# PERMIT

## SEWAGE DISPOSAL SYSTEM

SUBDIVISION Cisseel Farm LOT 2 ROAD 6905 Deer Valley Road

REPAIR - PURPOSE - SEPTIC SYSTEM HAS FAILED.

DEER VALLEY RD INDICATE NORTH - NAME ADJOINING ROADWAY AS BASE LINE  
NO WELLS ACROSS RD

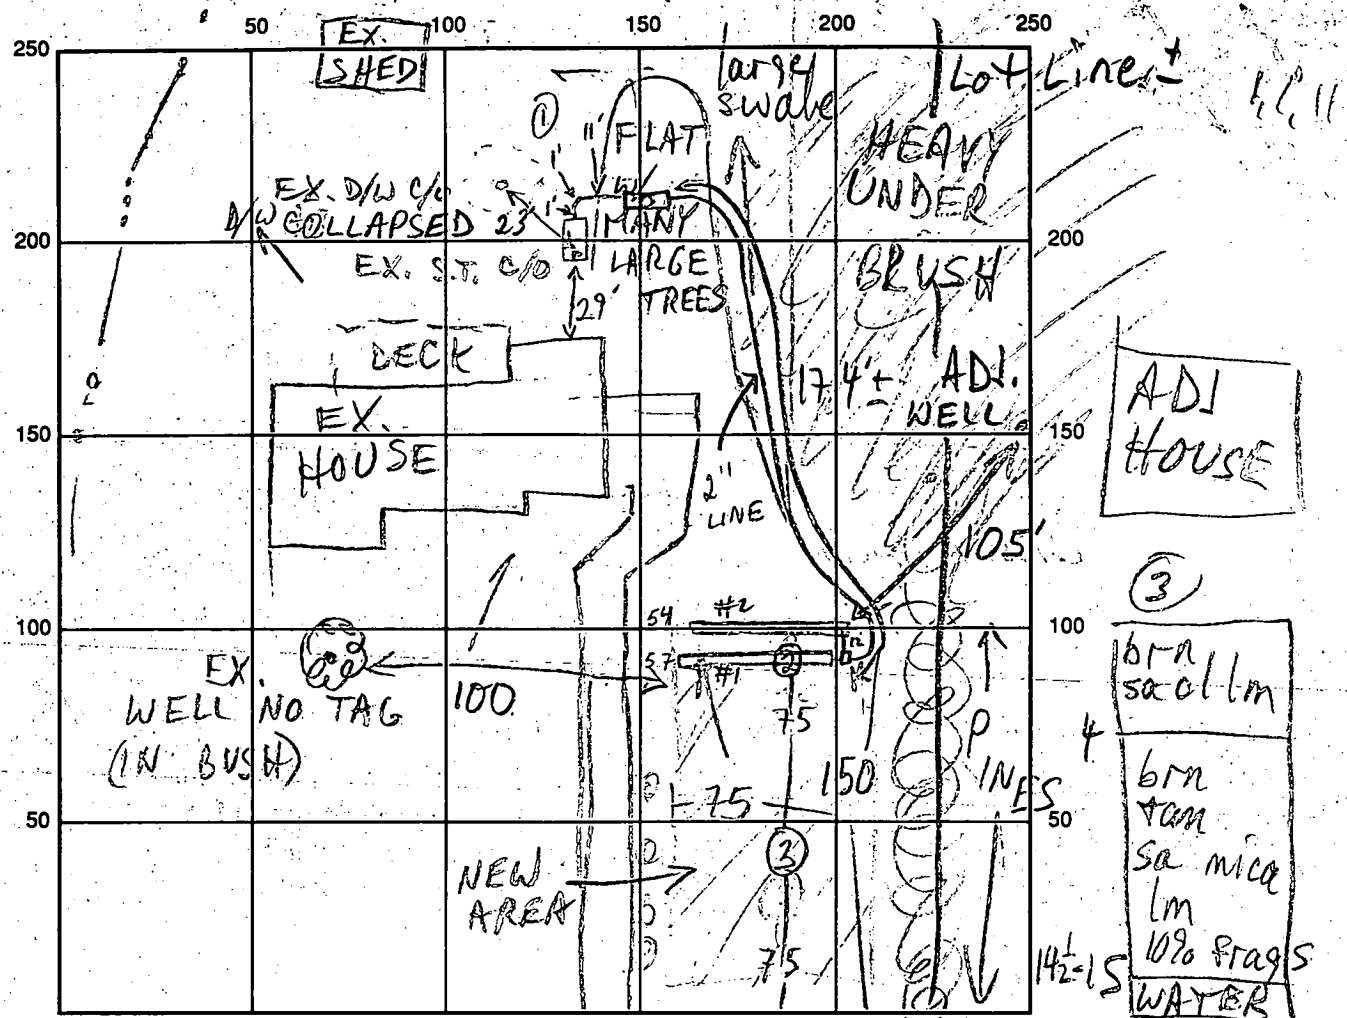
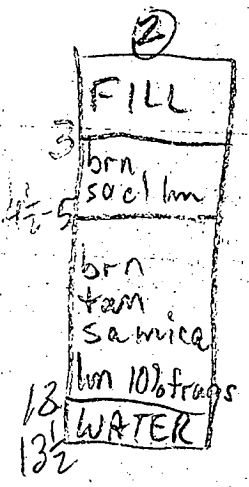
REMARKS: 7/5/96 SHALLOW H<sub>2</sub>O @ 8' IN TEST HOLE IN REAR; ONLY REMAINING AREA IN FRONT. (PUMPED SEPTIC SYSTEM REQ'D)  
9/3/96 D.B. & TRENCHES @ LOW END OF REPAIR AREA; CONSIDERED REQUESTING INSTALLER TO MOVE D.B., BUT SINCE HIGHER ELEV WOULD NOT HAVE CHANGED PUMP SPECS, D.B. OK;  
COVER TRENCHES; CALL WHEN PUMP INSTALLED MR 9/19/96 PUMP PIT, LINE

DATE SYSTEM APPROVED 9/20/96 INSPECTOR M. Rittich  
 OK TO COVER; INSTALLER REPORTS OWNER WANTS TO MAINTAIN D/W; I ADVISED NW NEEDS TO GO; STILL NEED PUMP TEST (MR) 9/20/96 PUMP OK, D/W COLLAPSED (MR)

INLET 4' BOT 9' 2 55' TRENCHES AT HIGHEST PART OF NEW SEPTIC AREA (ALONG ROADSIDE)  
1000 GAL PUMP PIT w/ALARM

INDICATE NORTH - NAME ADJOINING ROADWAY AS BASE LINE

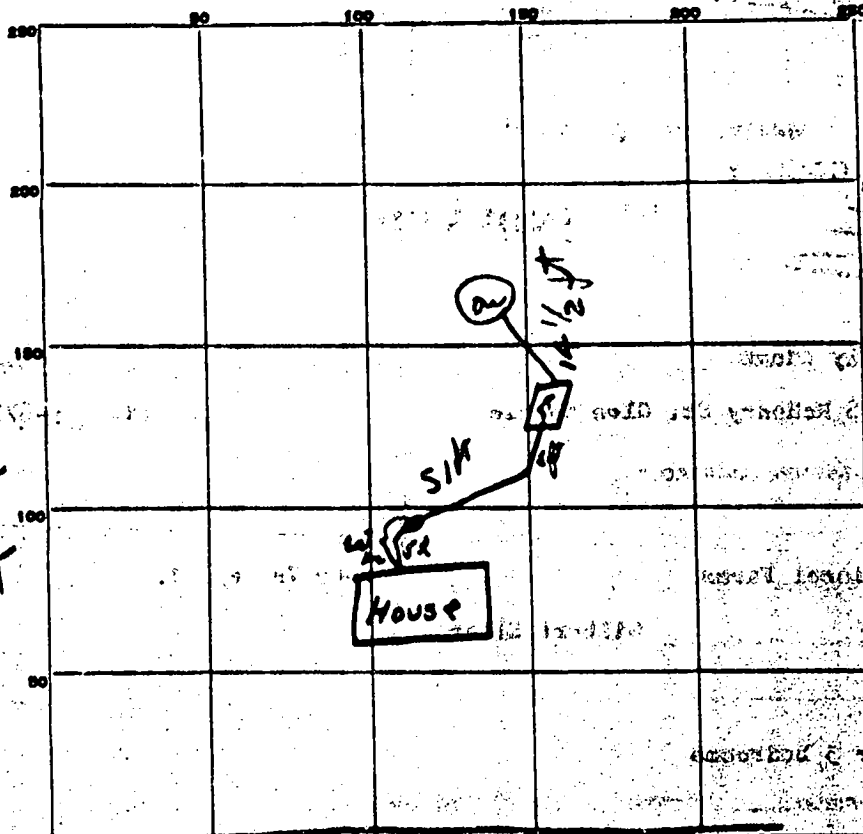
REMARKS 1/31/64 (1) needs long sewer assembly lead on pipe 5ft from tank  
Took one's 8" diameter cleanout pipe - drilled hole needed 1" additional pipe  
area (2) Den. Well needs 6" gravel on outside of block (3) Top cover to  
installed (4" reinforced concrete). Must call when job is complete for  
final approval & have well be posted. Summary (1) Yes (2) Yes  
(3) Yes RH 14 Feb 64
